G.O. No. 1138.

CPS - South Kanara Area - Drinking water supply - Construction of a well at Daregudde - Sanctioned by the PEO, Mangalore - Papers recorded. ——— x ———

Report to accompany the estimate for constructing a well at Daregudde

Village { No 64
Name Darigudde

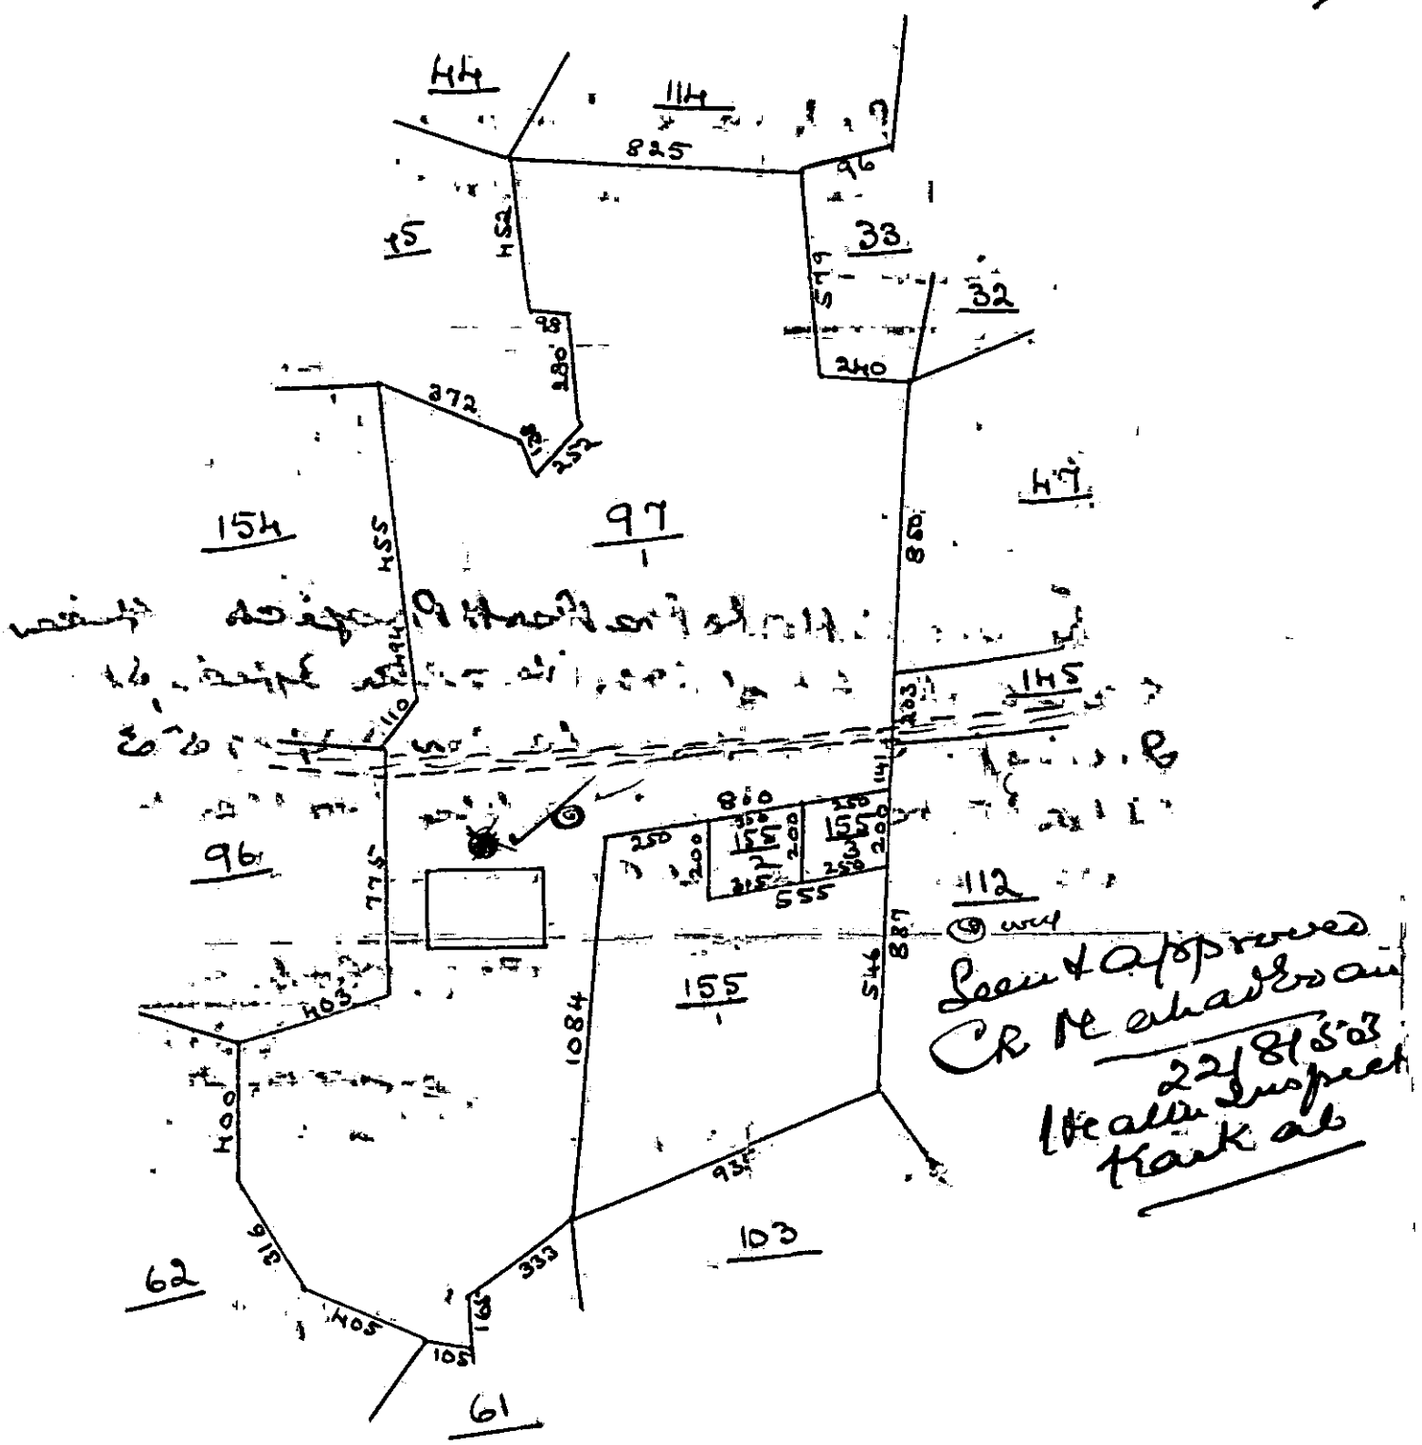
Please let me know whether the site selected for the construction of well is suitable. The site is on the Bidar - Belvai - Alizur Road

Recommended to the Asstt Project Officer Karkal, by Dr. Health Officer, Kanara. I inspected the site on 22/8/53. The site is suitable for the proposed well and is recommended.
